Flight Procedures Cover Page	Task Action: FLIGHT CHECK	Task Type: STAR	Estimated Chart Date: 12/26/2024	APWS Task ID: AA44332A36DE43D2A7206E0EBBE9D77E	APWS Project ID: AF2AE8CD6CB244B1F64A0123BA84DC
Procedure: STAR DIRBY (RNAV) TWO		Enroute: YES	Specialist: Neidigh, Jon		Agreement Number:
Airport ID: KLAX			Airport City: LOS ANGELES		State: CA
Facility ID:	Facility Type:	Flight Inspection Remark Type: New FC Slot			
Procedure Comments: ADDED TCUPS TRANSITION, REVISED RDHOT AND TILLT TRANSITIONS CONTACT CASIMIR L. TABAKA 405-954-7931 QUALITY 35 CHECKED QUALITY 41 CHECKED

FIPC DME/DME FORM						
PROCEDURE: STAR DIRBY (RNAV) TWO			AIRPORT NAME: LOS ANGELES INTL		AIRPORT ID: KLAX	SPECIAL CONTROL NO: SG-08-144-24
FAC ID: DIRBY2		CITY: LOS ANGELES			ST: CA	ORIG CHART DATE: 12/26/2024
DFL TYPE: PROC/D	THIRD PARTY: ☐ YES	EST. TIME ON SITE: 1.0	REIMB. NUMBER:	PTS TASK ID: AA44332A36DE43D2A7206E0EBBE9D77E		
PREFLIGHT NOTES						
REVIEWER:					DATE:	
COMMENTS:					CHECK ONE: ☐ FLT CK REQ ☐ NFCR ☐ REJECT	
						YES NO
					CPV COMPLETE?	X
PROCEDURE RESULTS						
INSPECTION DATE: 10/08/2024	CREW #: VN235	N #: N72	INSTRUMENT PROCEDURE STATUS: ☒ SAT ☐ SAT W/CHANGES ☐ UNSAT		ARINC CODING: ☒ SAT ☐

AUTOMATED AL-237 DIRBY ARRIVAL

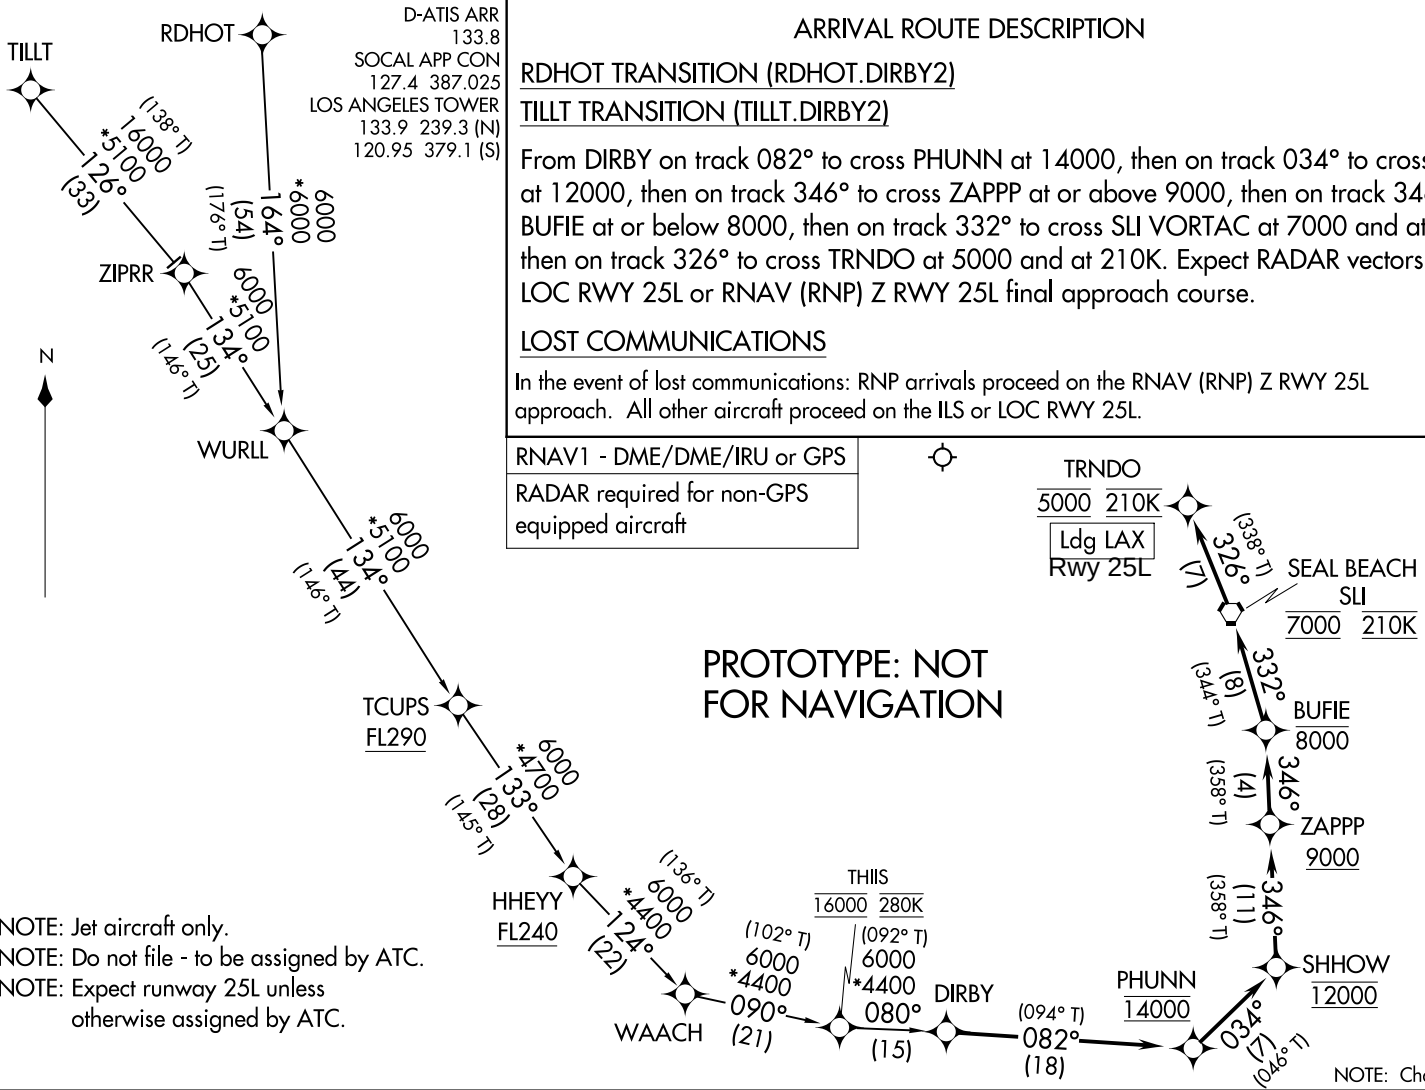
This request is for approval of the descent gradient of 285 ft/NM from SLI VORTAC to TRNDO.

The Descent Gradient (284.9700123699612) from SLI VORTAC to TRNDO is calculated from an altitude of 7000 and 210 kts at SLI VORTAC to an altitude of 5000 and 210 kts at TRNDO, over a distance of 7.02 NM. The course from SLI VORTAC to TRNDO is 326.2 magnetic / 338.2 true. When the STAR is in use a headwind prevails more often than a tailwind.

Due to surrounding Los Angeles Basin ingress / egress procedures, there is an operational need to have the DIRBY STAR design retain long standing arrival procedures for aircraft landing KLAX routed via SLI VORTAC.

Due to air traffic volume, complexity, and Class B containment requirements, ATC has determined that it is not operationally acceptable to change the location of the STAR descent from SLI VORTAC or the altitude restriction because it would force the descent too early and would result in a potential Class B redesign and/or changes to numerous other procedures.
